FST2XT Software Change History

Issued by: NEW Lift Steuerungsbau GmbH

Release: FST V0188, 06.02.2025

8) Hydraulic Rail Clamping:

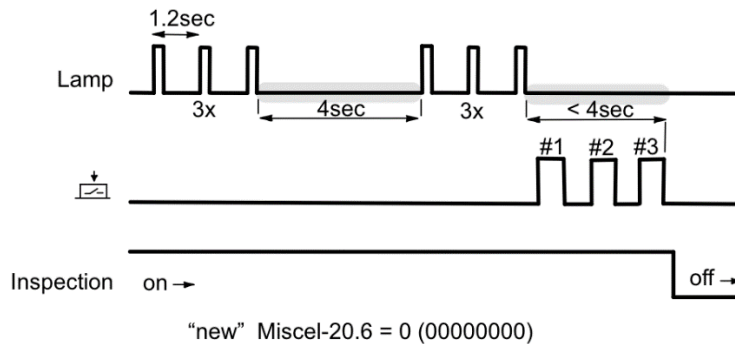
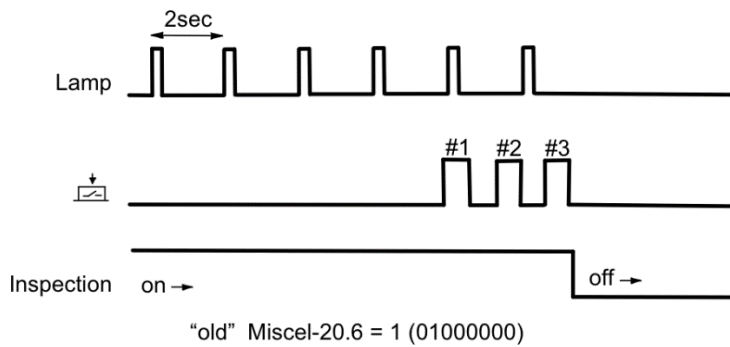
for the automatic lift-rope tensioning mode (FST V0173), the maximum (fixed) operating wait time has been extended from 3 to 8 seconds.
